| APPLICATION NO.   | FILING DATE | FIRST NAMED INVENTOR | ATTORNEY DOCKET NO.      | CONFIRMATION NO.       |
|---|-------------|----------------------|--------------------------|------------------------|
| 10/765,881  | 01/29/2004  | Toshiyuki Suzuki     | 2635-200                 | 2291                   |

| <b>Office Action Summary</b> | <b>Application No.</b><br>10/765,881 | <b>Applicant(s)</b><br>SUZUKI ET AL. |  |

## **DETAILED ACTION**

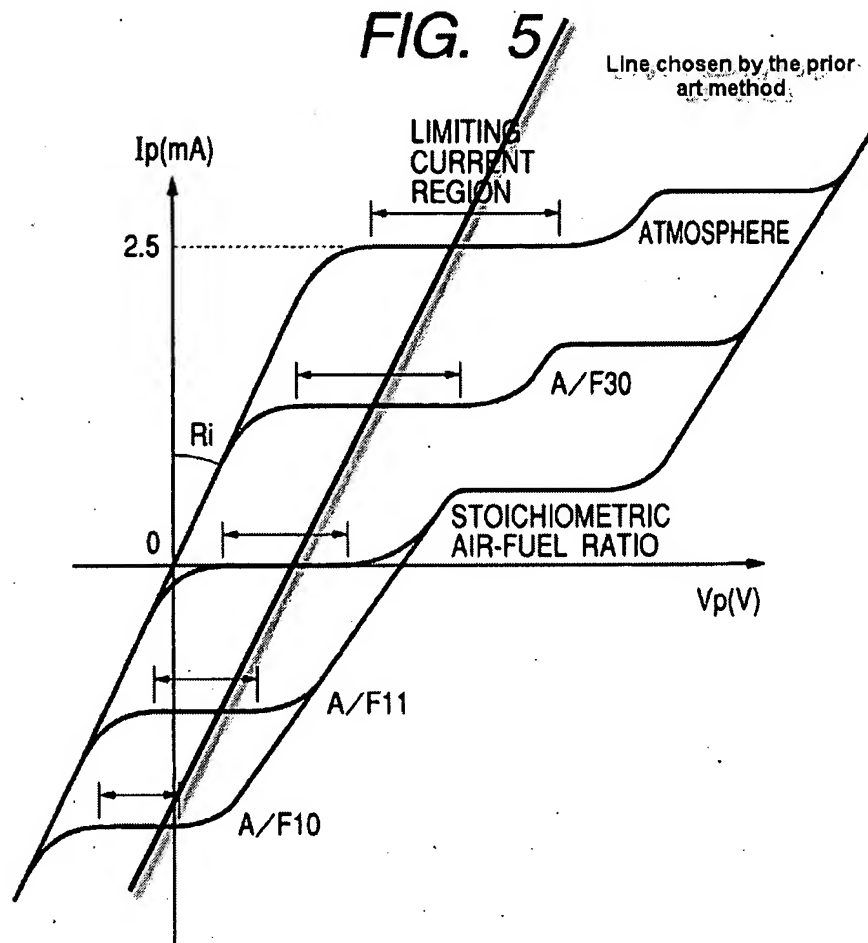
7. With respect to claim 2 (those limitations not covered above), Okazaki discloses an applied voltage control unit connected to said electrodes of the sensor element for controlling the applied voltage on the basis of an applied voltage characteristic defined linearly (see fig. 8, 10, or 11 and col. 12, l. 63 through col. 13, l. 9 as an example), and an element current detecting unit 50 connected to said electrodes for detecting an element current (col. 5, l. 61 through col. 6, l. 6). With respect to said applied voltage characteristic being set on a basis of a width of a limiting current region, it is noted that this limitation does not appear to further define any structure of the invention. Rather this limitation merely sets forth the process for how the characteristic line is chosen and the process utilized to choose the line doesn't further define the actual structure of the applied voltage control unit. In the absence of any specifically defined trait for the chosen characteristic line that is not disclosed nor rendered by the prior art, this limitation cannot be considered to further define the structure of the apparatus itself. The examiner notes that a characteristic line that is parallel to the slope defined by  $R_i$  in fig. 5 (i.e. a characteristic line chosen by the prior art means) would appear to extend through all of the limiting current regions of the instant invention. See the modified instant invention figure 5 below:

Whether or not this line here was chosen by the prior art method or on the basis of the applicant's knowledge that the limit current region is narrower in the rich A/F ratio regions doesn't change the structure of chosen characteristic line. The instant inventors could have arrive at the above line "on the basis of a width of a limiting current region" (i.e. the line could have been chosen such that it went through all the limit current regions for the sensor), but it would have had the same structure as the line chosen by the prior art method. Moreover, even if

the examiner were to interpret the limitation “on the basis of a width of a limiting current region on each concentration level” as implying some structure significance, the use of characteristic lines in general are inherently set based on the widths of a limiting current regions. In particular, the whole purpose of characteristic lines is to alter the voltage applied such that the sensor is always in a limit current region. See col. 1, ll. 33-43. If the line is chosen such that one is in a limit current region, then one has chosen that line on a basis of a width of the limit current region because the widths define where that limit current region is. See fig. 8 and 11 of Okazaki where the line slope is repeatedly changed in order to maintain the voltage at a point safely between the widths of each limit current region. This line is clearly chosen based on knowledge of the widths of the limiting current regions.
